# Addendum No. 06

April 11, 2024

## BAKERSFIELD COLLEGE STUDENT HOUSING (for DSA Project Name - New Residence Hall)

**PBK PROJECT NO.:** S2103400AR  
**DSA FILE NO.:** 15-C1  
**DSA APPLICATION NO.:** 02-122124

A6.4

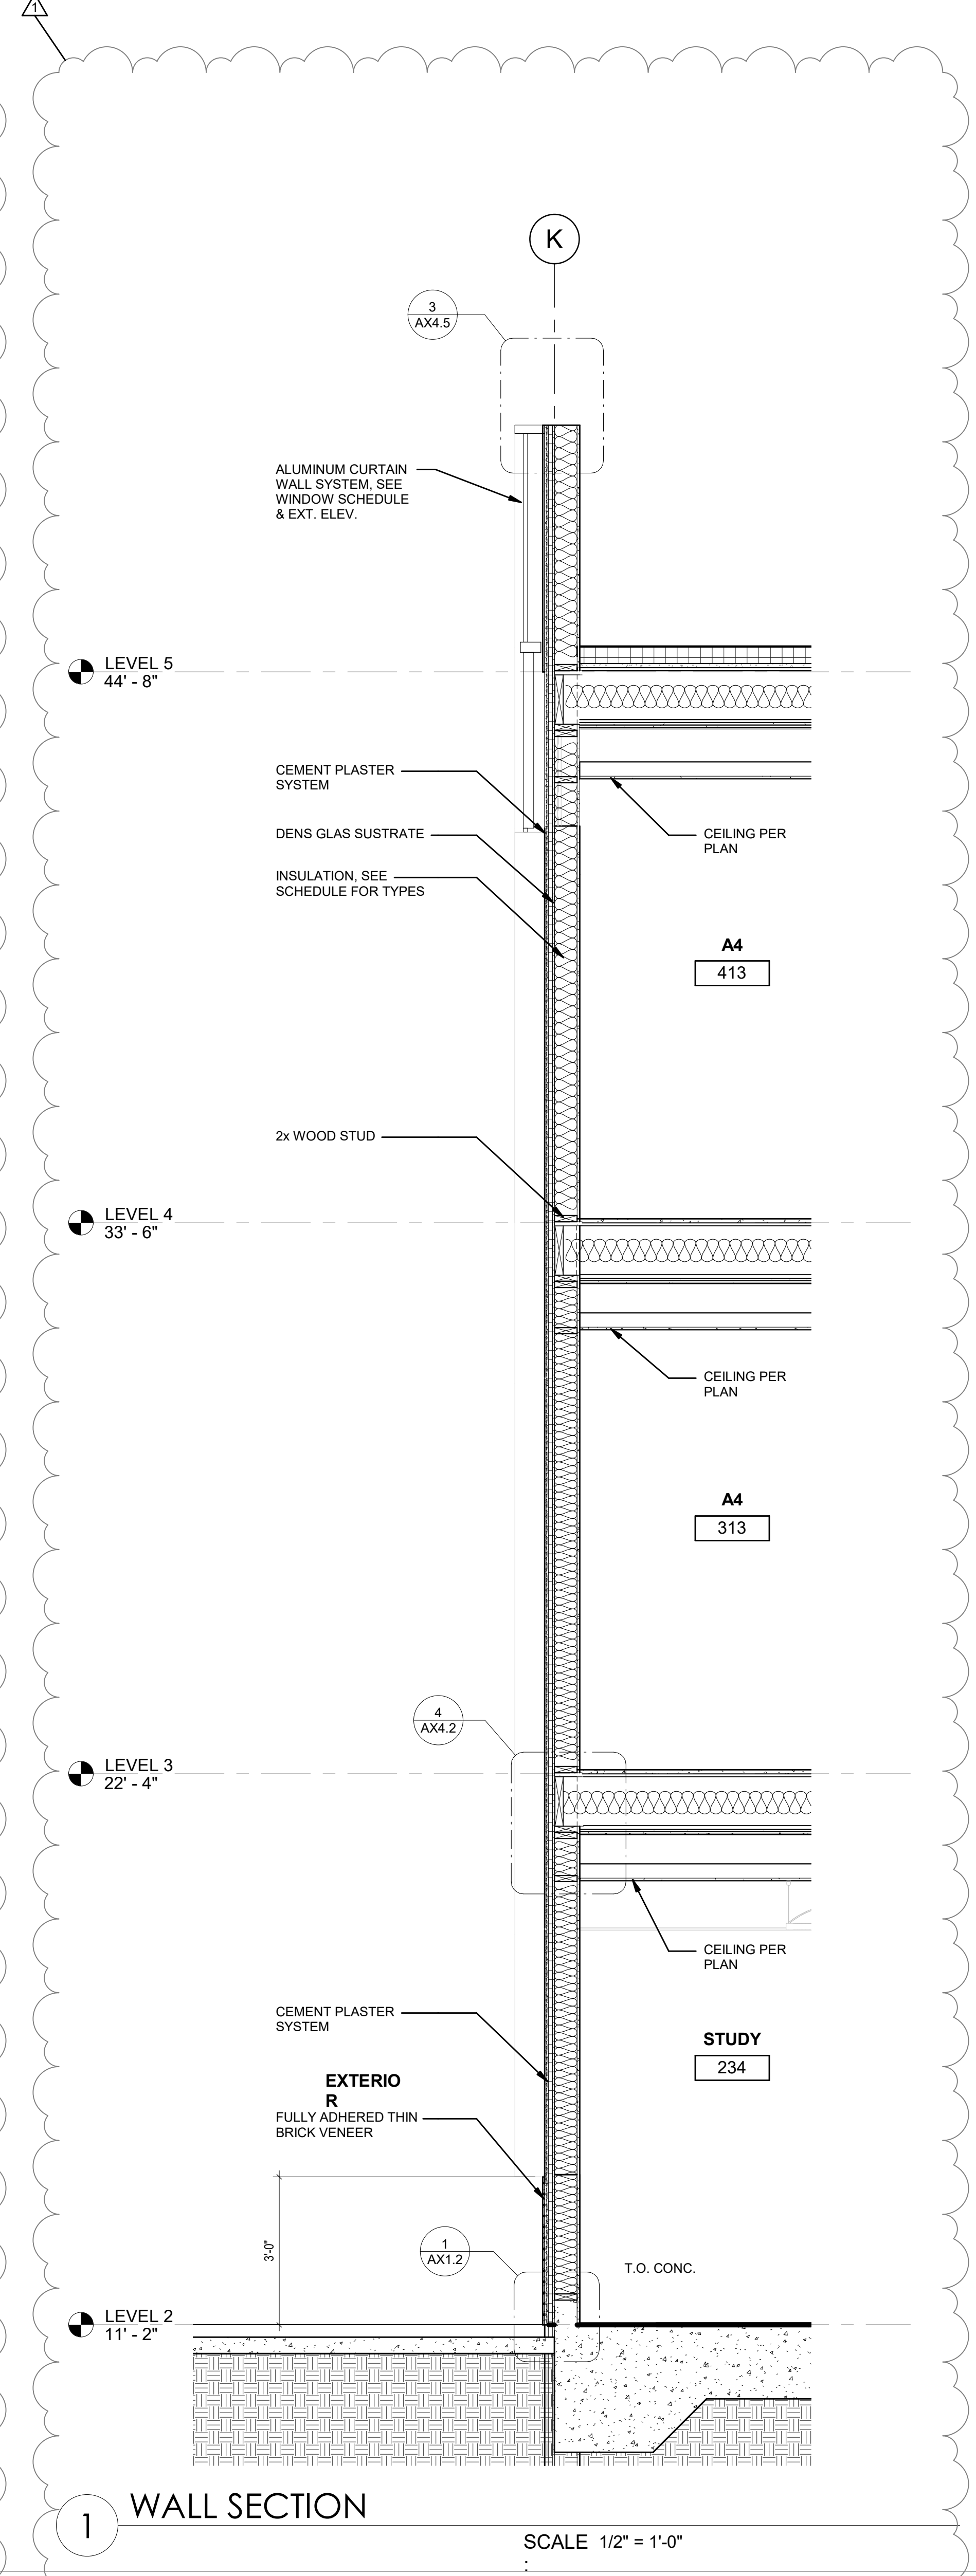
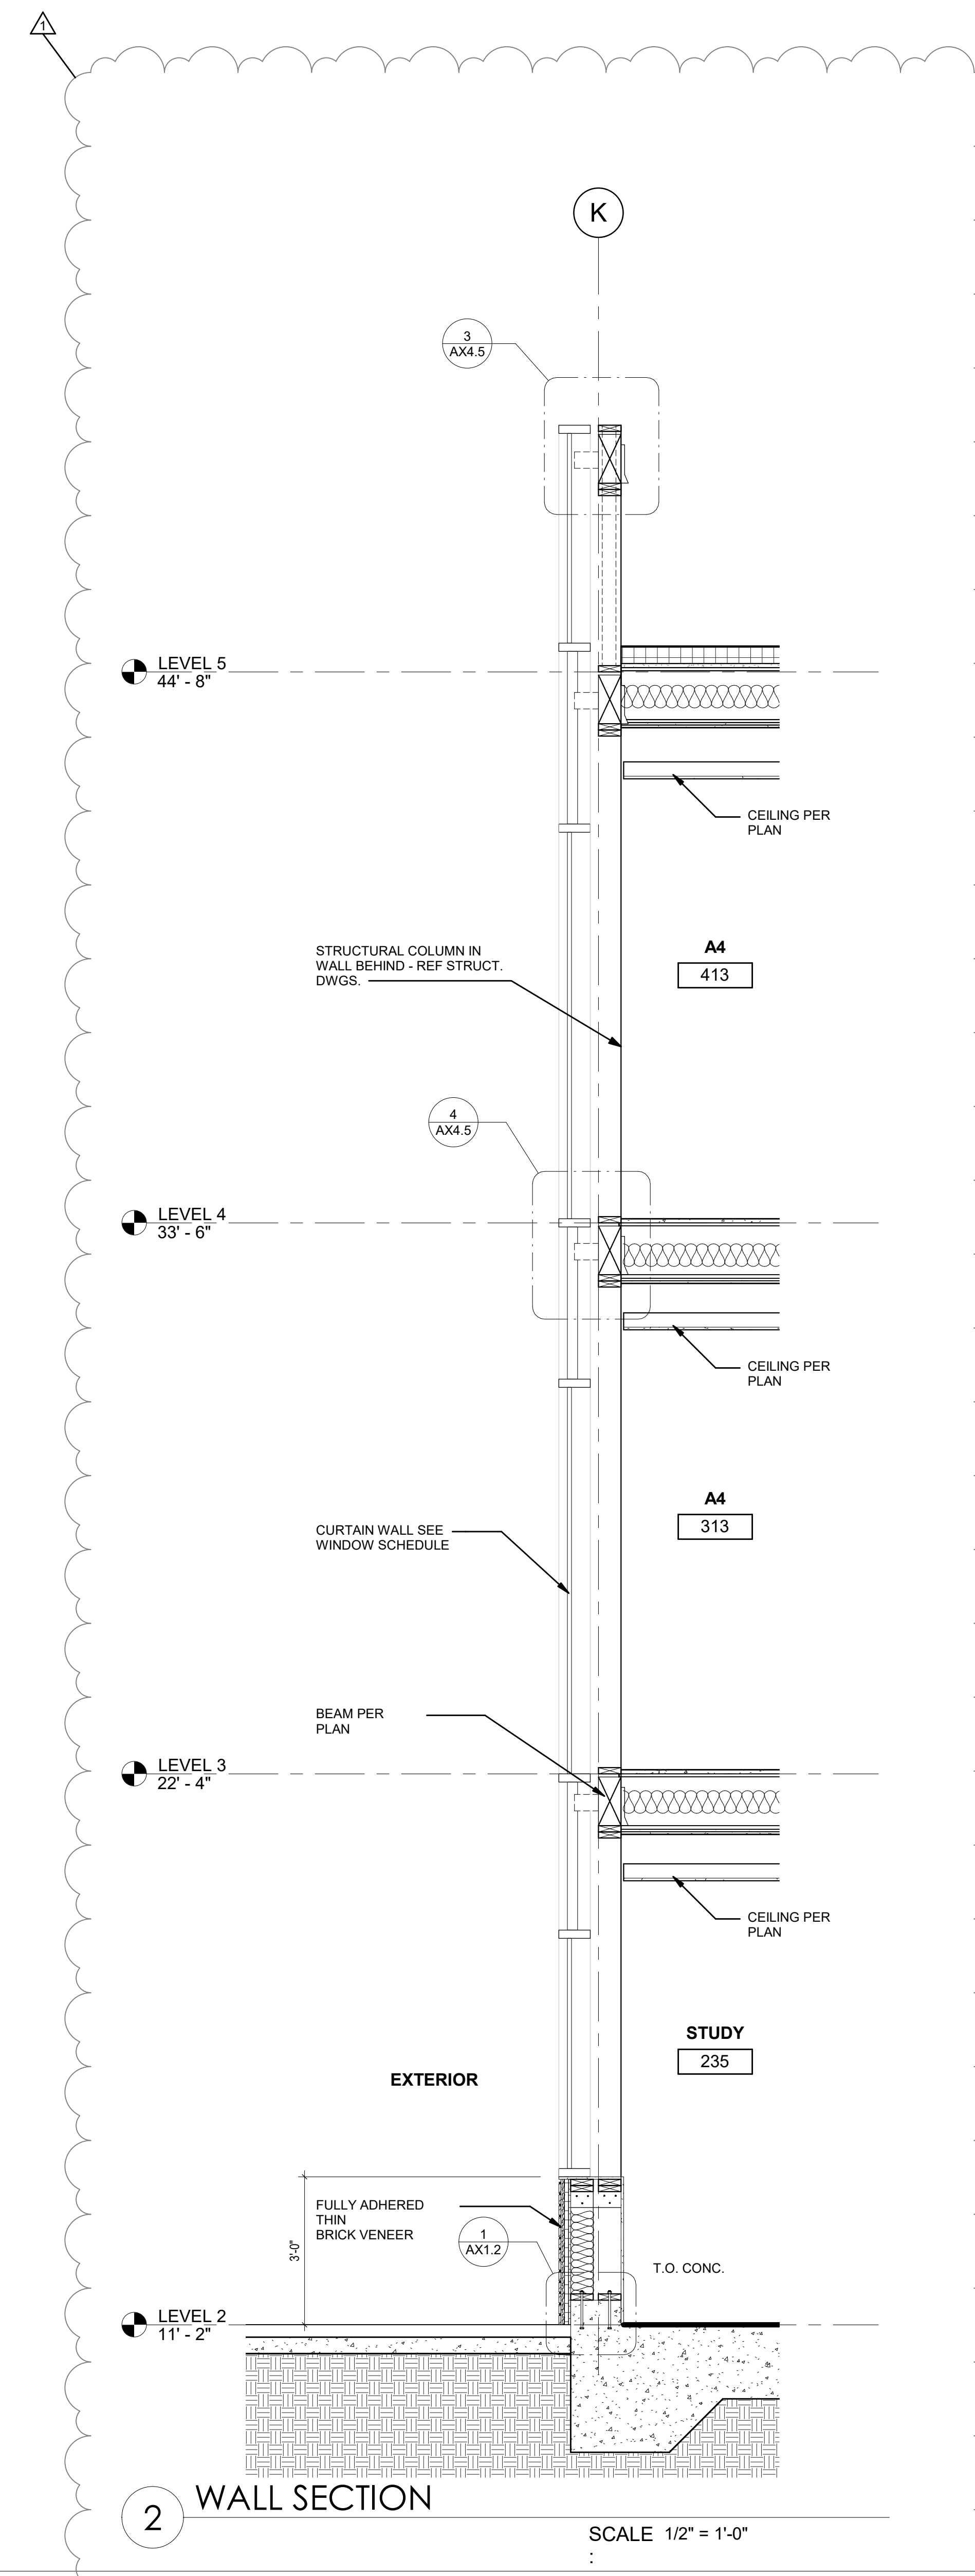
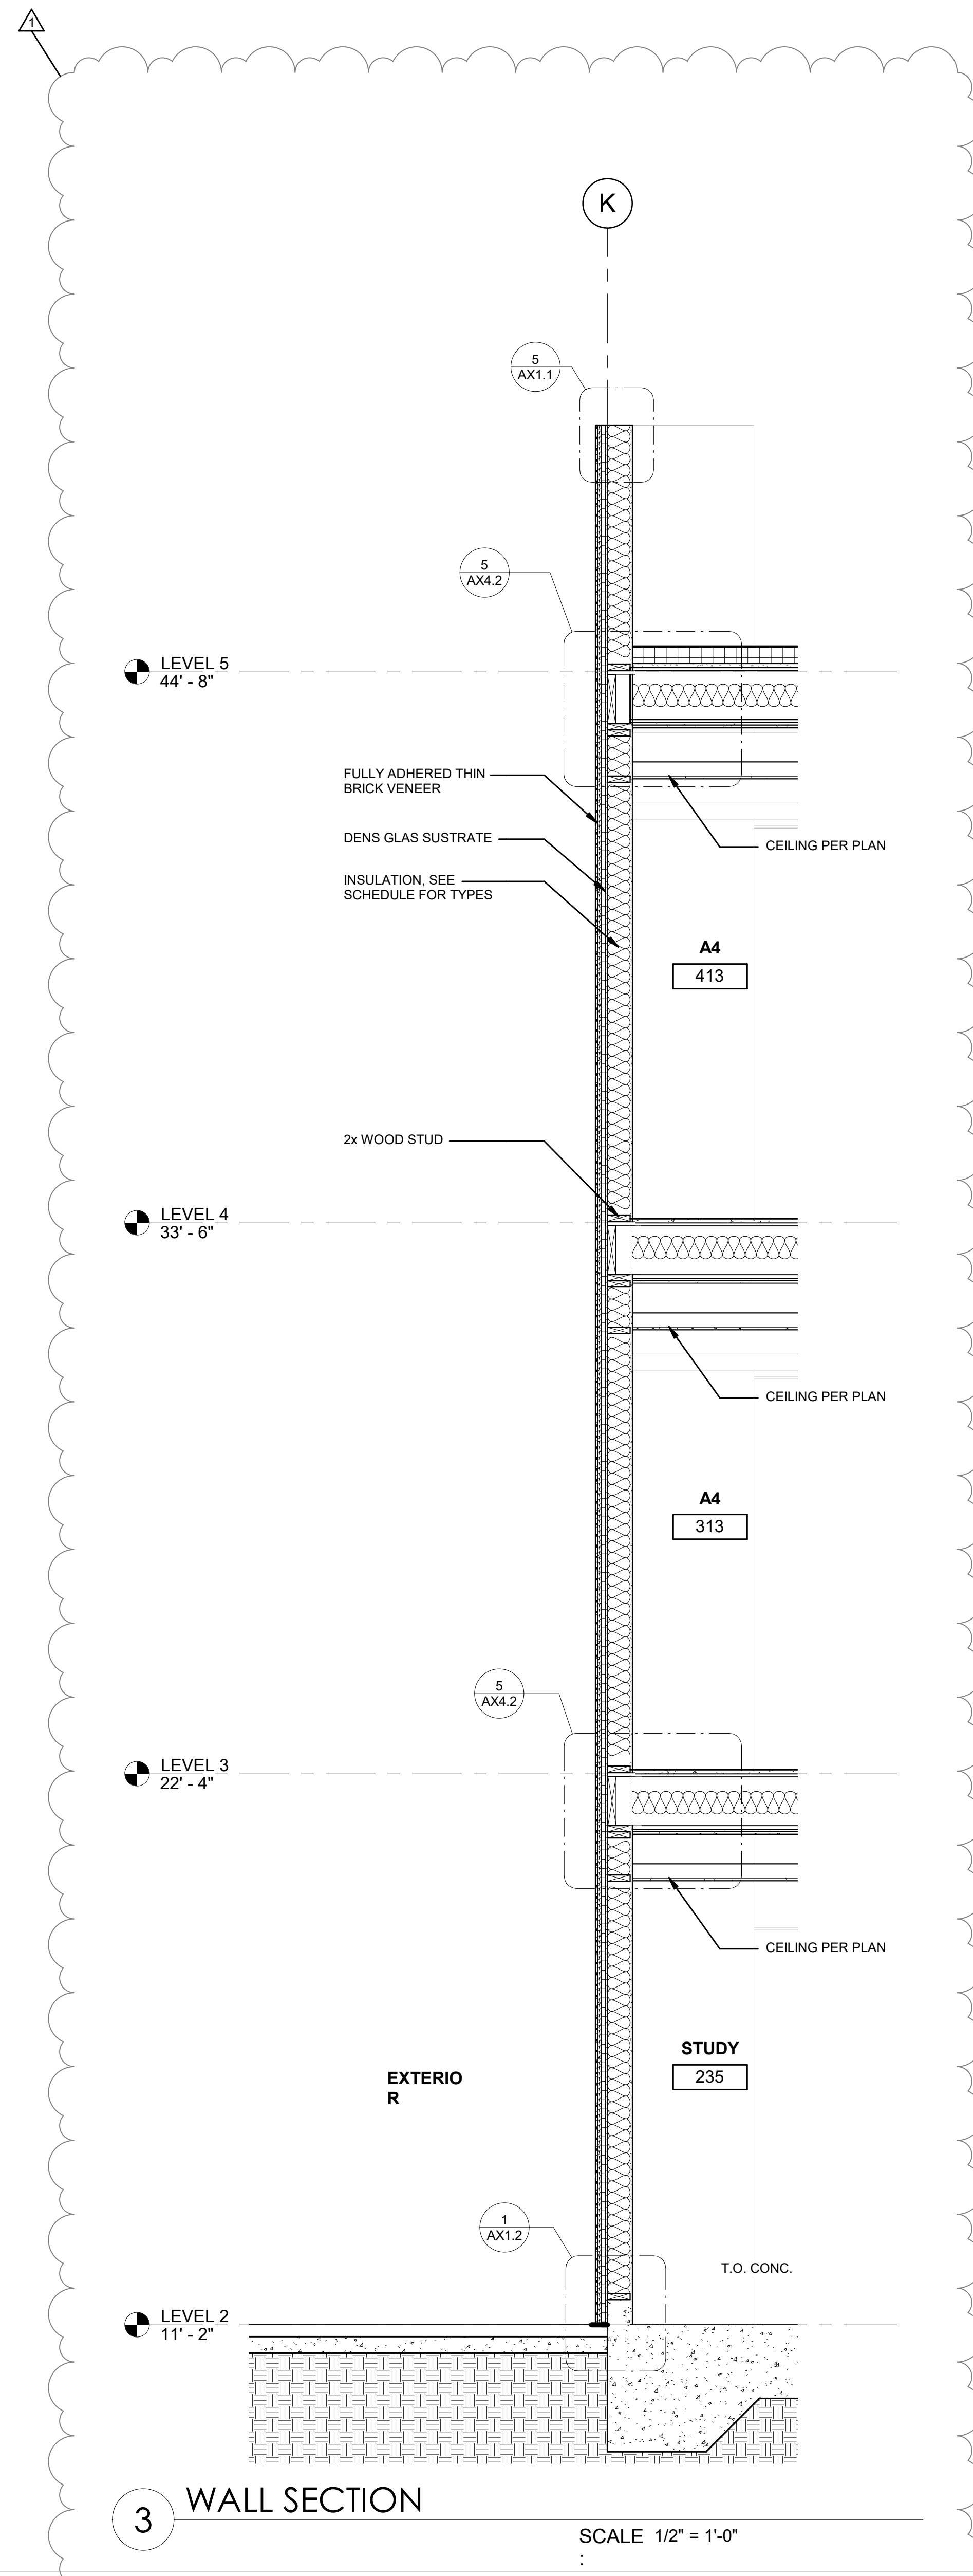
- AD6-22**    **A6.4 – Wall Sections:** Replace the sheet in its entirety. Revised references on drawings 1 and 2. See attached revised drawing A6.4 with all changes clouded.
